West Burton Solar Project

Supporting Environmental Information Report Change Application

PINS reference: EN010132
Document reference: CR1/WB9.2

Appendix A Order Limits Change

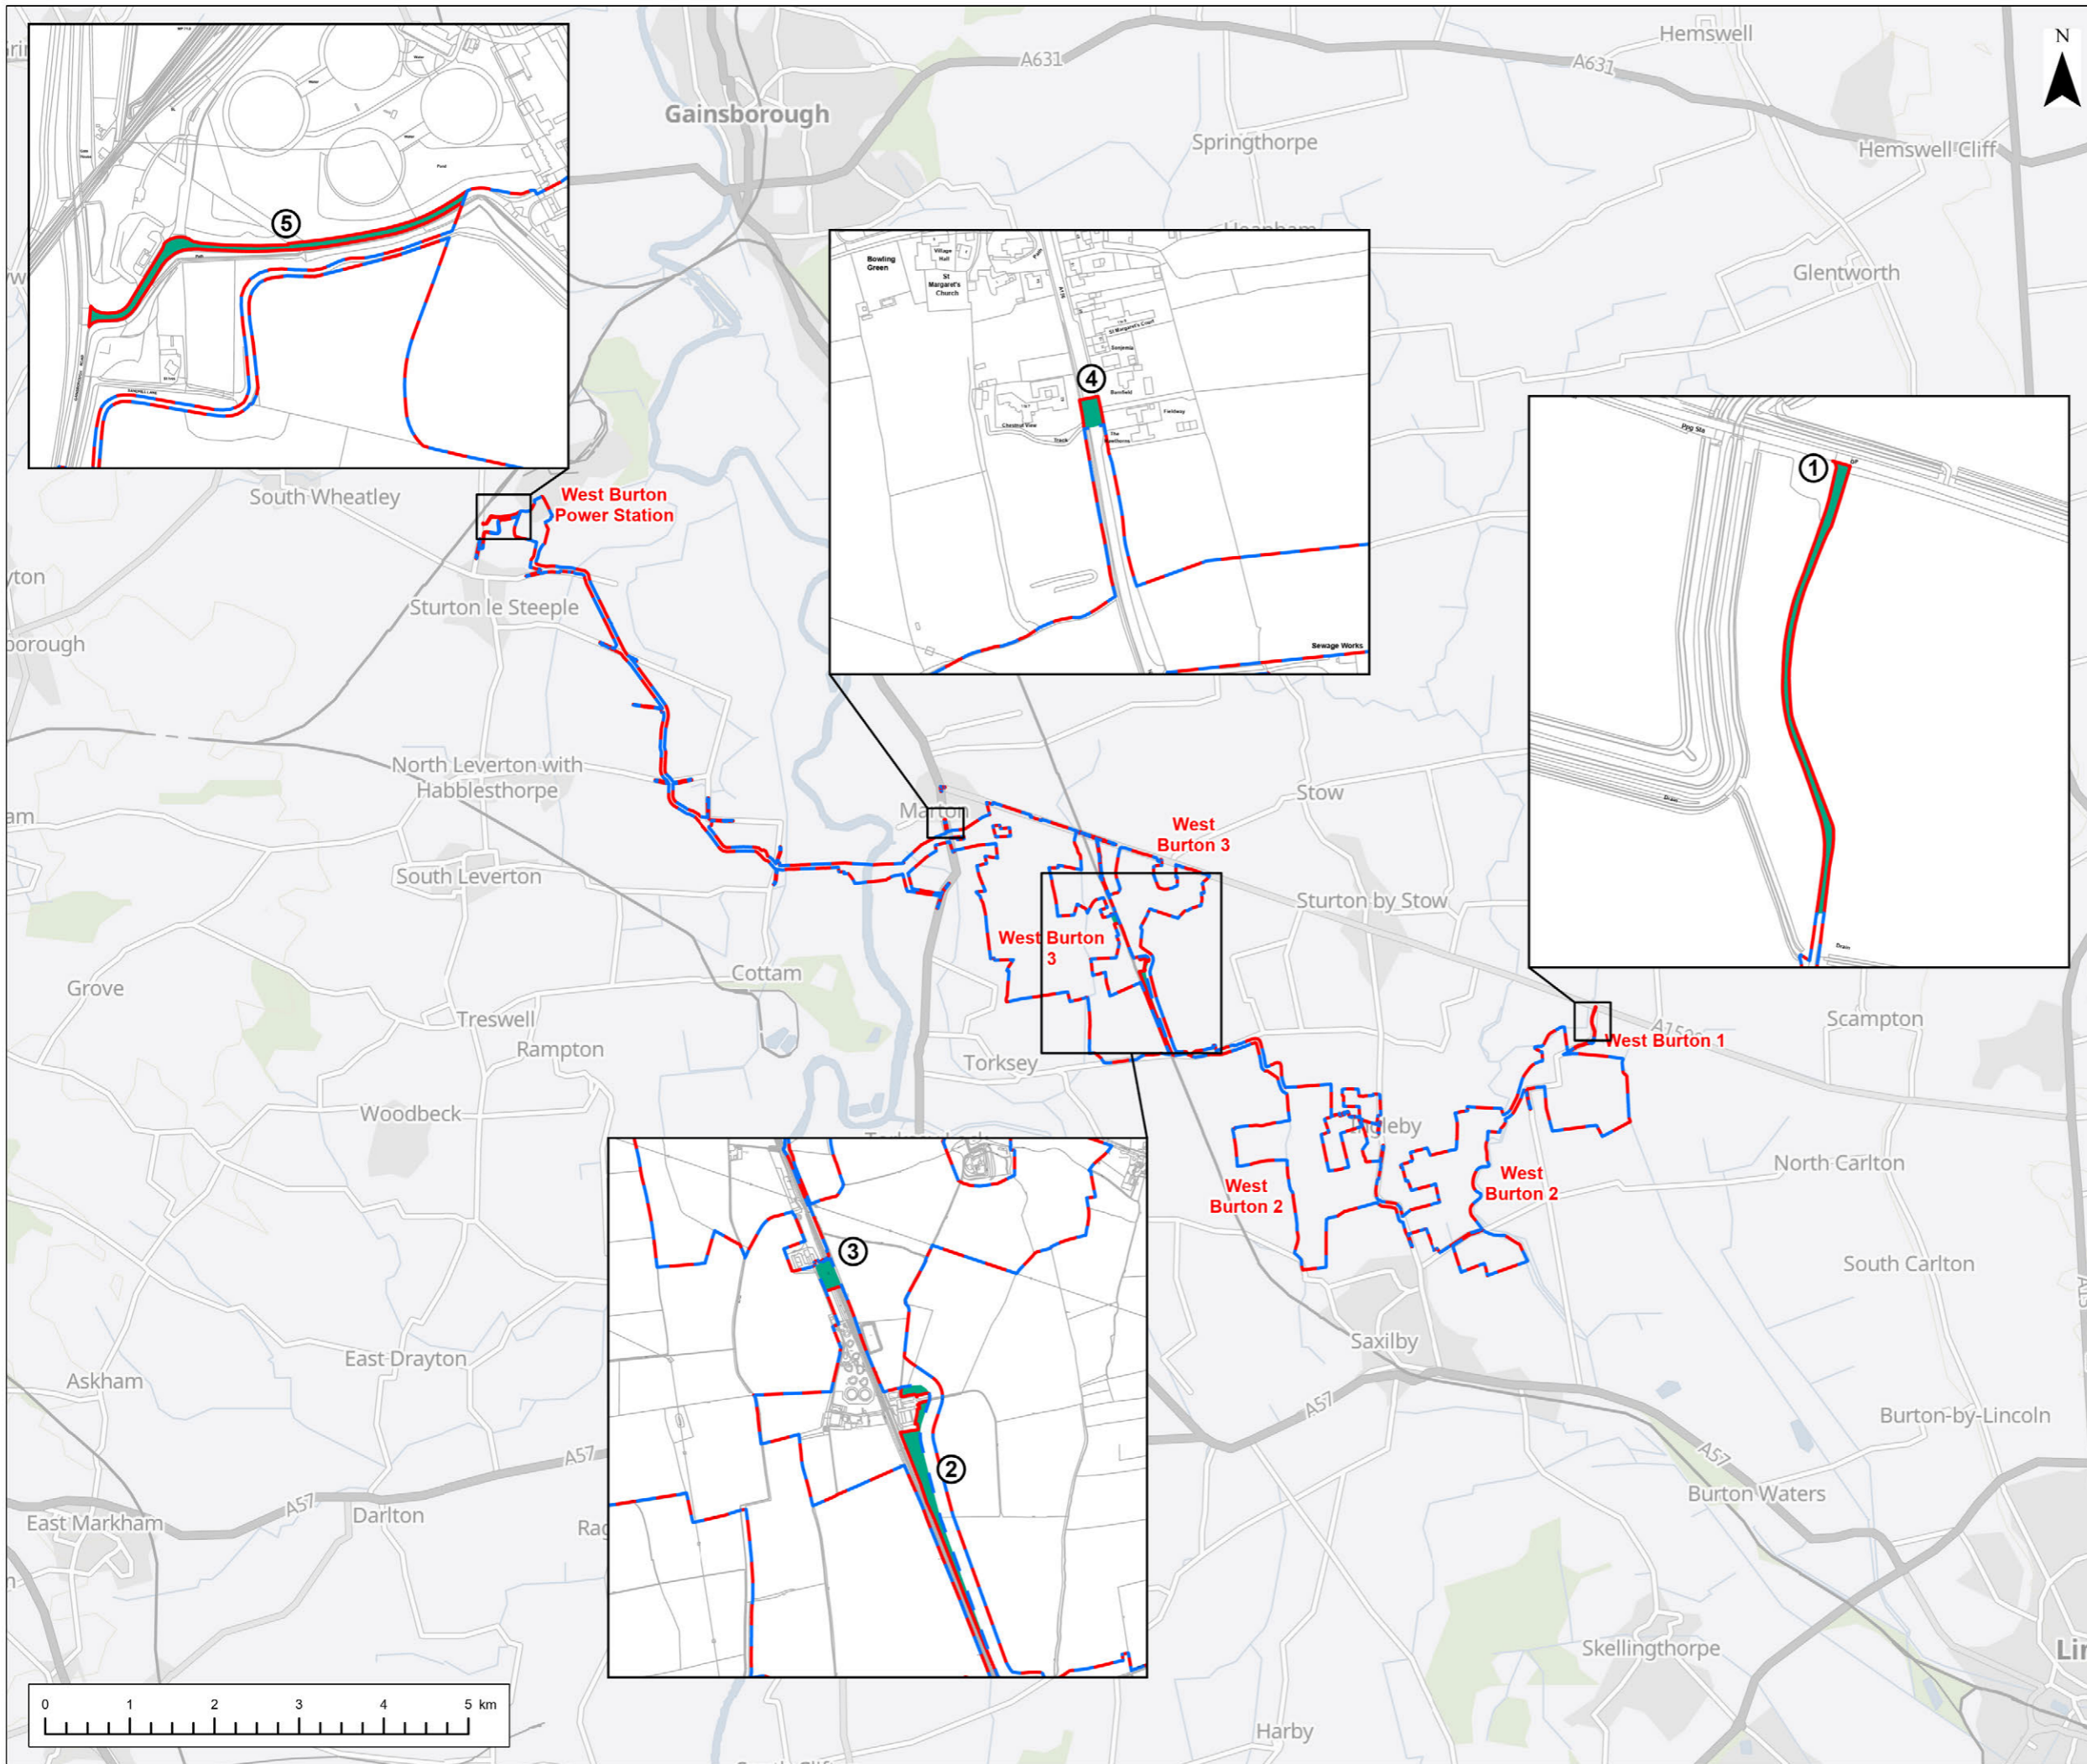
2.2 Change 1: Extension to Public Highway between West Burton 1 and A1500

2.3 Change 2: Cable Corridor Widening, Stow Park

2.4 Change 3: Extension at railway between the East and West parts of West Burton 3

2.5 Change 4: Visibility splay for Cable Route Corridor Access AC110

2.6 Change 5: Extension to include use of West Burton Power Station Access Road
